# CONNECT MAIN STREET

## VOLUME II: CONCEPTUAL PLANS

## Public Improvement Plan Comment Statement

Figure 7-7: Public Improvement Plans - Sheet 7

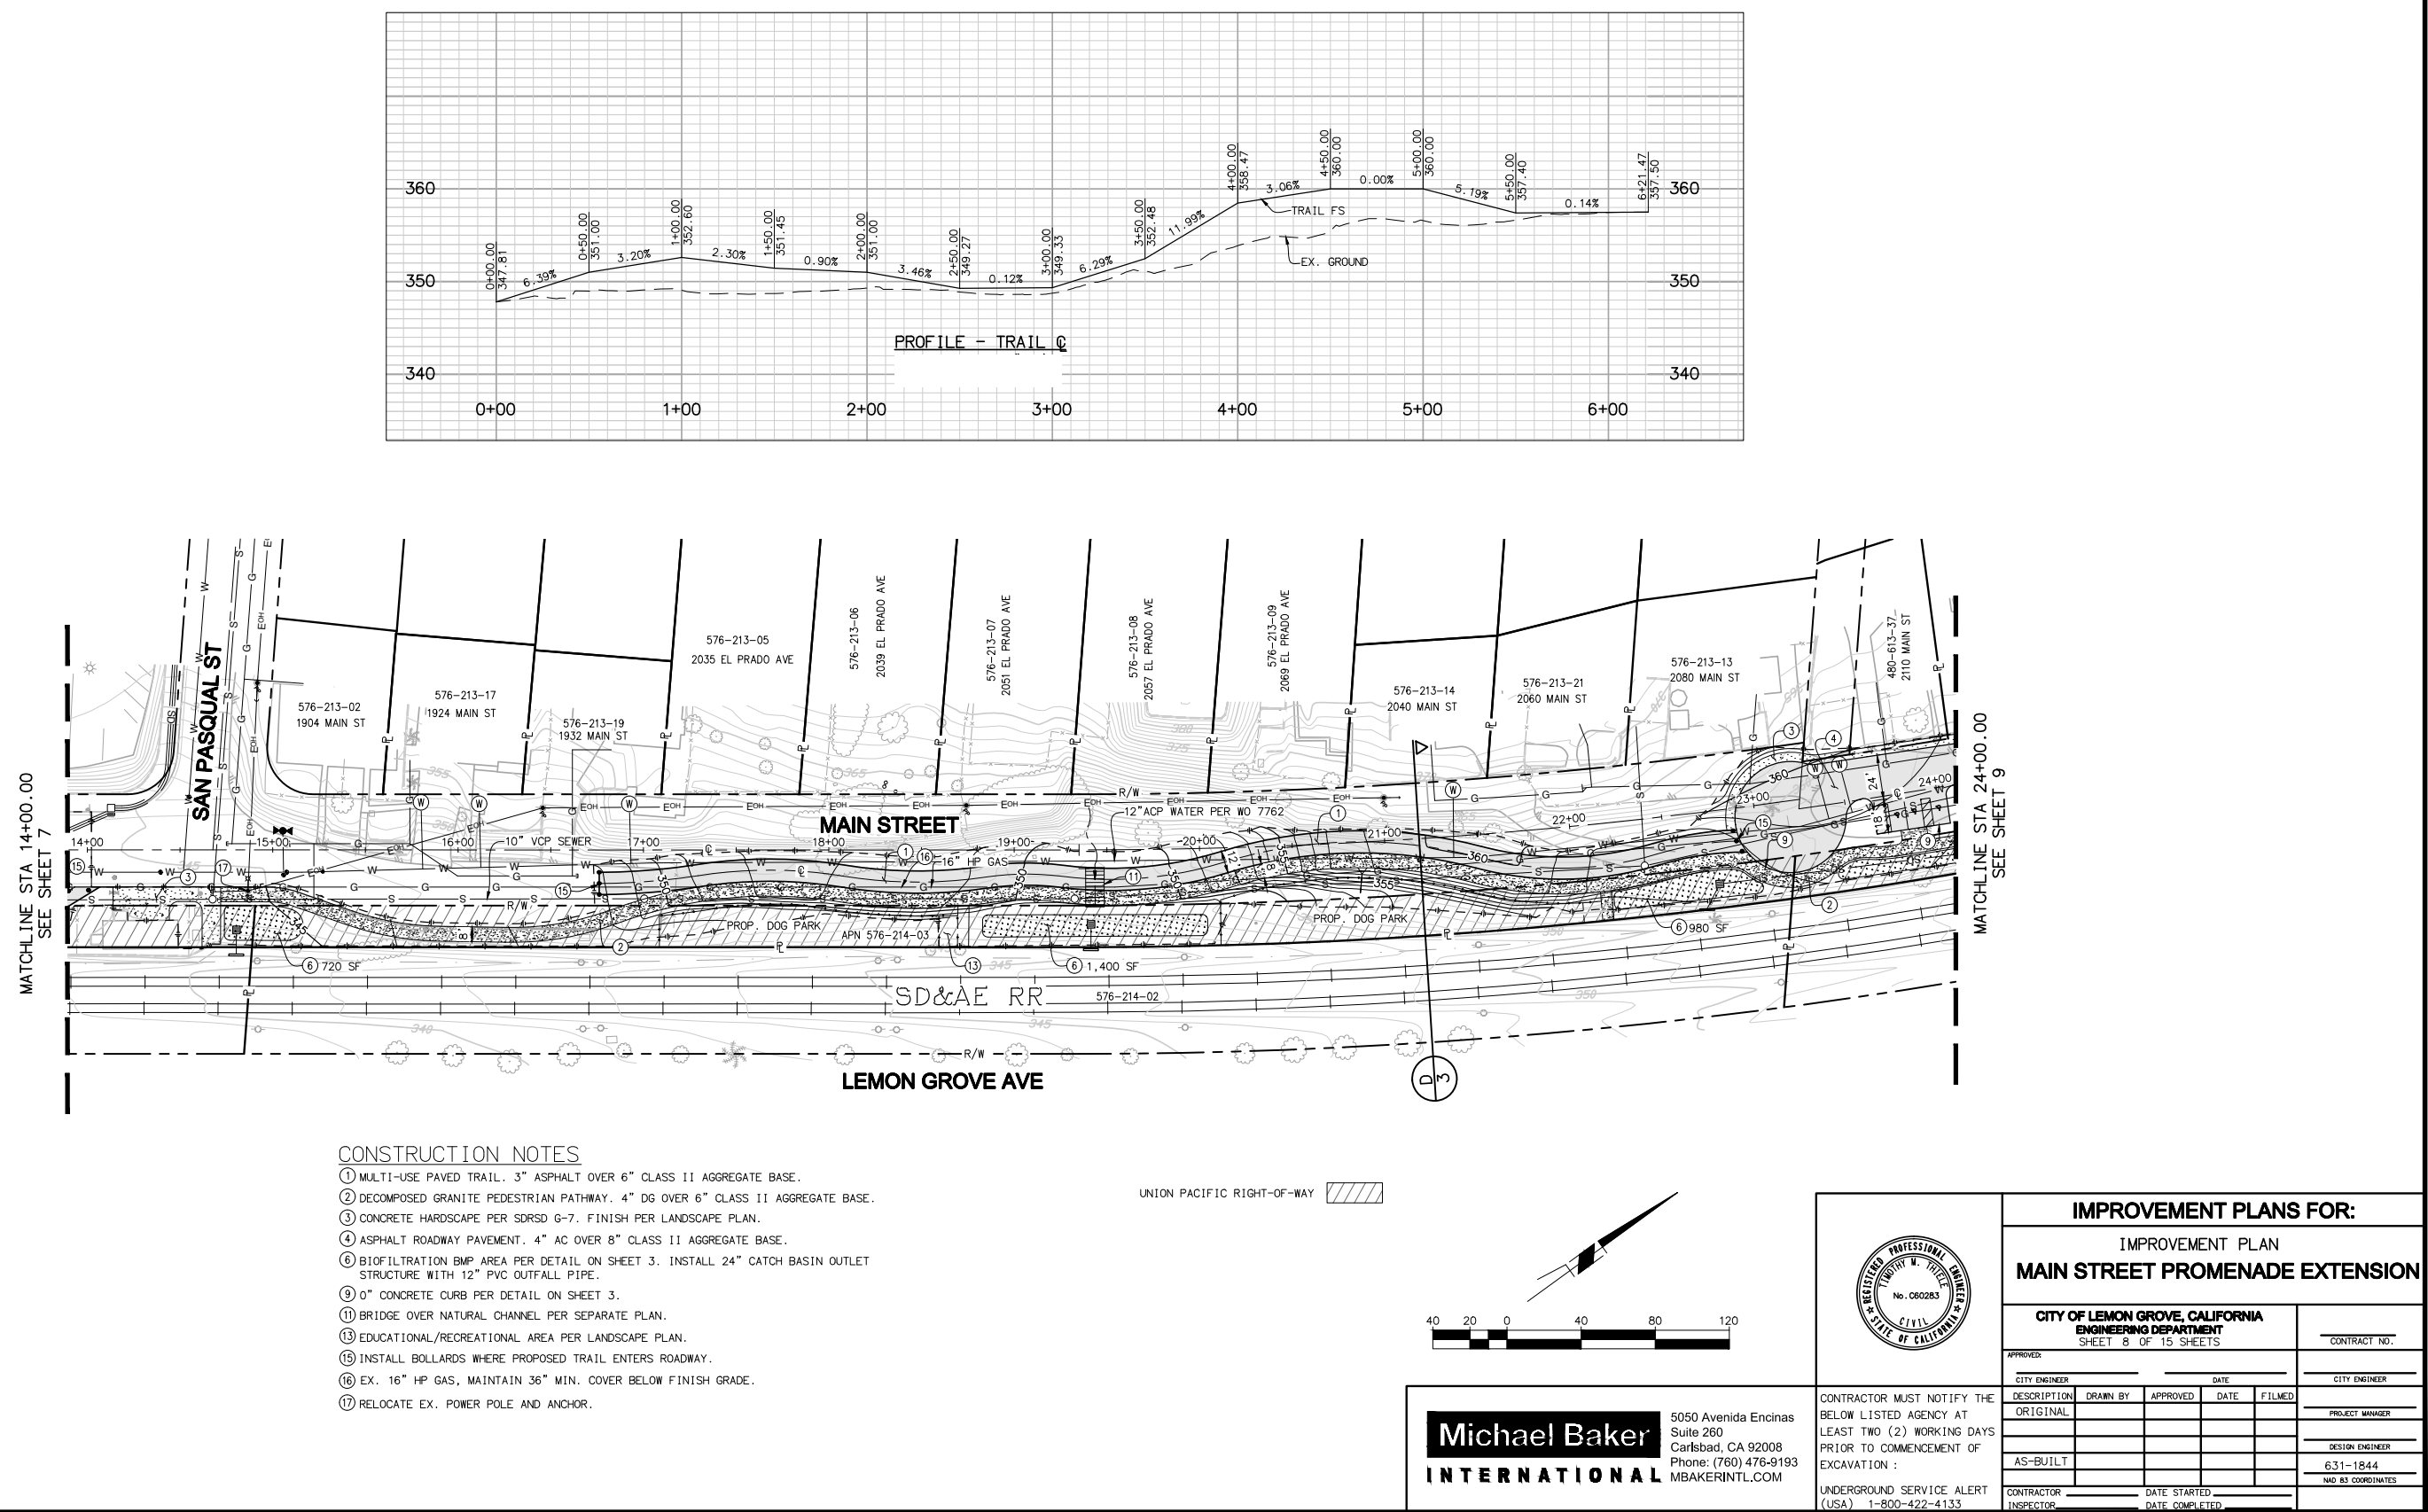
**Comment U-11:** Helix will relocate fire hydrant (reference sheet 7)

**Comment U-14:** Sheet 7: Bio-filtration will be in conflict with the existing 16" HP gas main. A solution may be to move the bio-filtration to the Educational/recreational area, northeast of Massachusetts and Main St.

**Comment U-19:** Show new SDG&E vault location (reference sheet 7).

**Comment U-23:** In reference to sheet 7, Helix will abandon the 10" ACP.

**Comment D-14:** Verify locations of storm drain lines on Sheet 7. The City's MS4 GIS layer shows that the storm drain line east of the trolley tracks comes back to the west side and joins with the open channel where the channel begins again just south of the main parking lot by the trolley station. The GIS file may not be correct as to the exact location, but the storm drain line east of the trolley tracks should come back to the west side and enter the main open channel at some point, and that connection is not shown on the plans.

Figure 7-9: Public Improvement Plans - Sheet 9

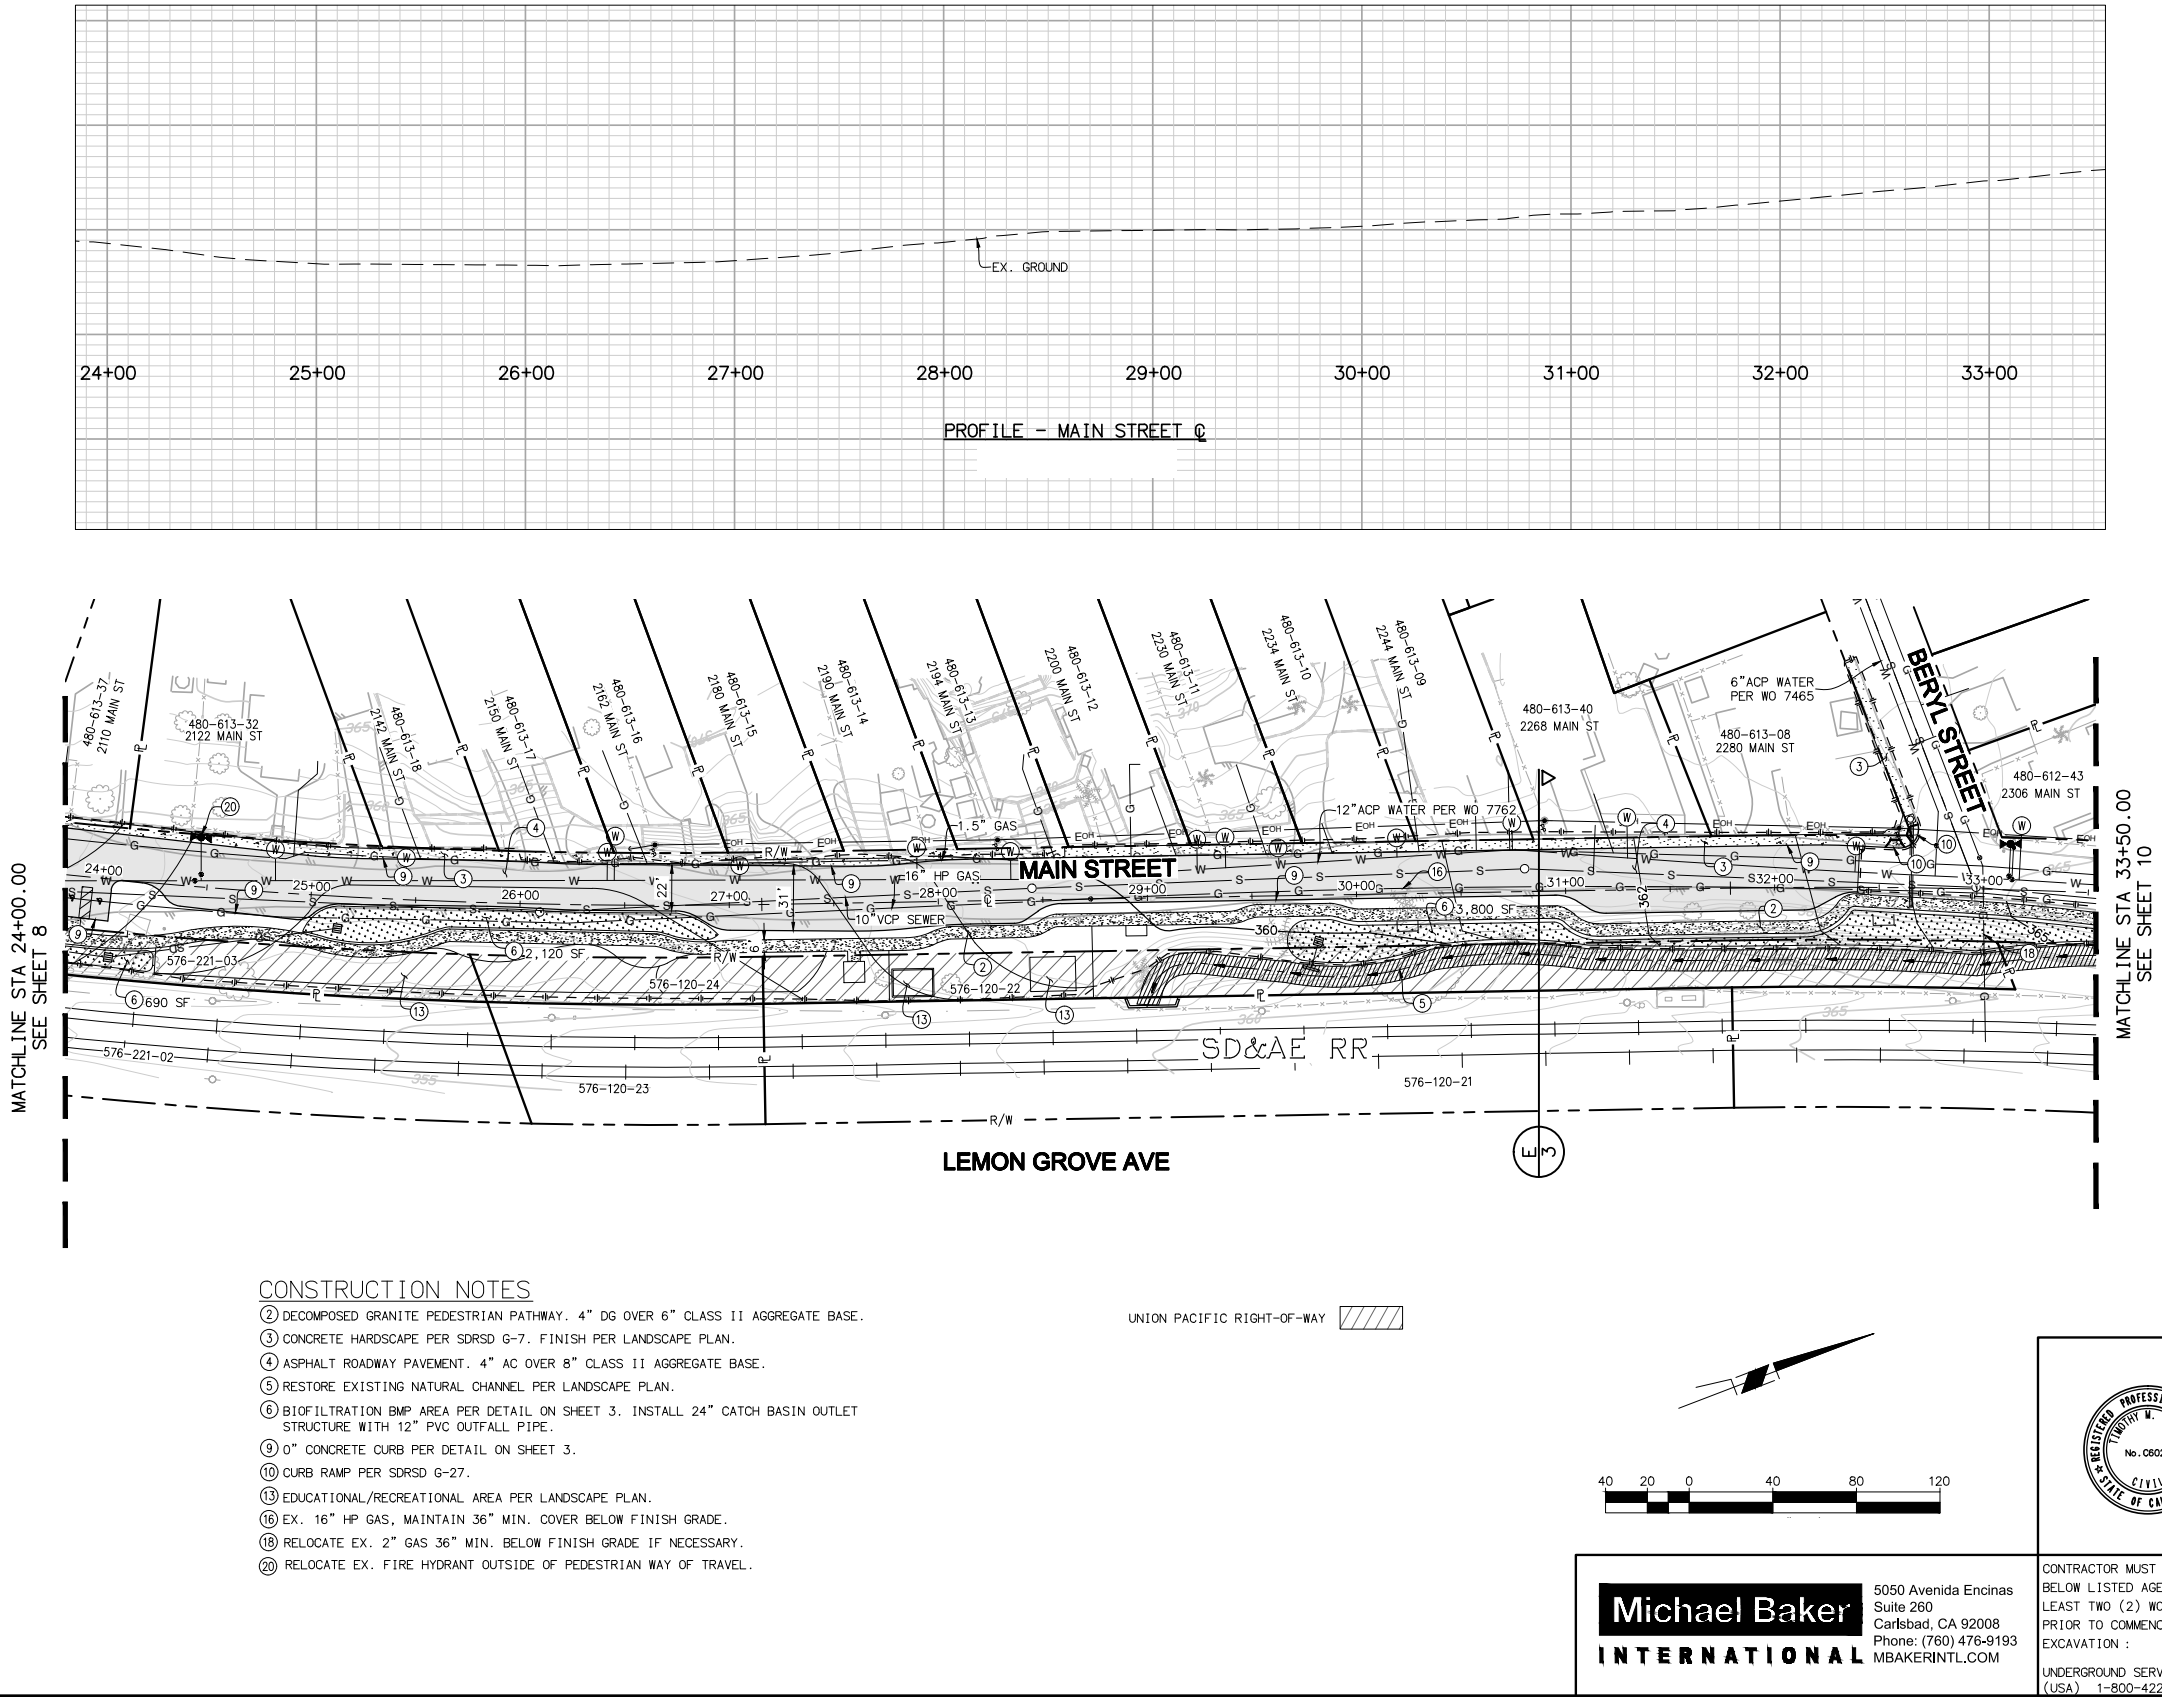
**Comment C-1:** All driveway entrances adjacent to proposed paths shall be per San Diego Regional Standard Drawings. Show the curb, gutter, sidewalks and driveway aprons on the west side of Main St. where appropriate (reference sheets 9 and 10). Consider a rolled-curb for continuous sidewalk.

**Comment C-4:** Assure proper driveway access to houses between San Pasqual and Beryl Streets. Show access for all houses adjacent to the cul-de-sacs (reference sheet 9).

**Comment U-7:** How does the fire hydrant work with a 5' walkway(reference sheet 9)

**Comment U-8:** Sewer MH is in the bio basin (reference sheet 9).

**Comment D-3:** Identify where drainage will go (reference sheet 9).
